EXTRATERRITORIAL ZONING COMMITTEE MEETING FEBRUARY 19, 2024, 5:00 PM AGENDA

Re: 8250 Marty Road (Klein) Extraterritorial CSM

Re: Klein Preliminary CSM Review

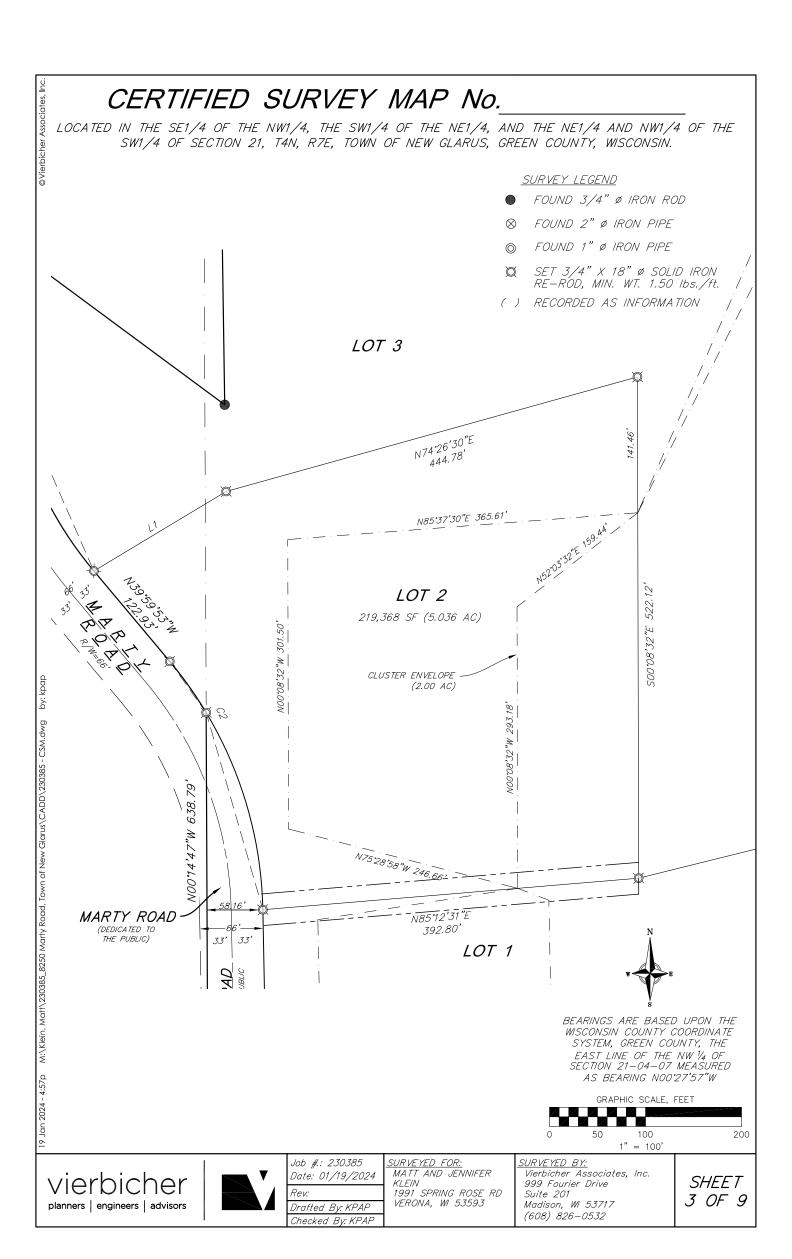
The slope of the hillsides proposed for the proposed lots vary with some sections that exceed a 20% grade. These areas have been noted on the CSM and are outside of proposed the cluster envelopes. Access for Lot 3 will require construction of a long driveway across areas where the terrain is steep. Therefore, we recommend the Town require lot 3 to submit a site plan for the proposed building location and which including a driveway plan for review and approval by the Town prior to building permit issuance. A note to this effect should be included on page 3 of the CSM stating:

"Residential home construction on Lot 3 will require submittal of a site plan demonstrating compliance with the Town of New Glarus Driveway Ordinance (Chapter 36) and depicting the proposed home location within the cluster envelope."

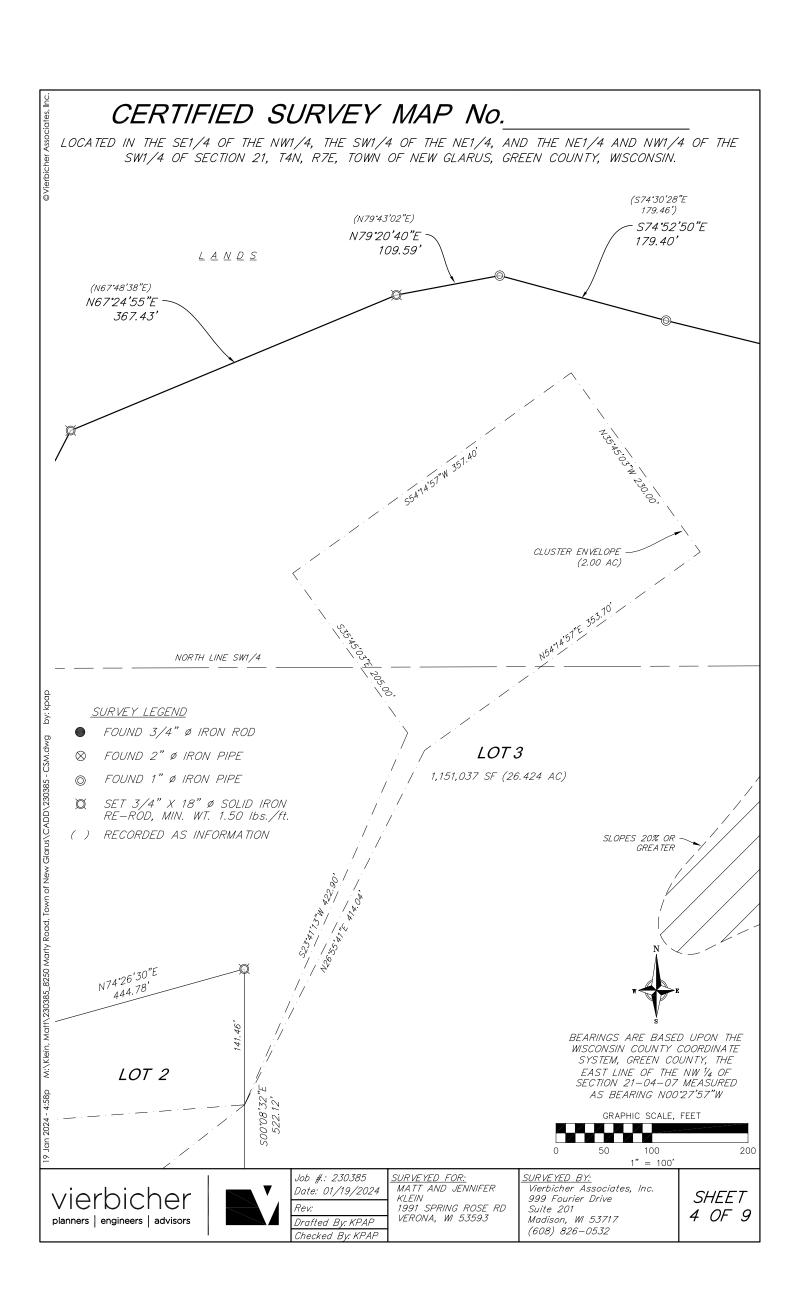
- b. Adjust the cluster envelope for CSM Lot 3 to have a western edge no closer than less than 80 feet from the eastern Marty Road right-of-way edge.
 - c. On Sheet 5, correct spelling of "pavement" and specify whose responsibility it will be to relocate the existing driveway, and when or via what triggering event.
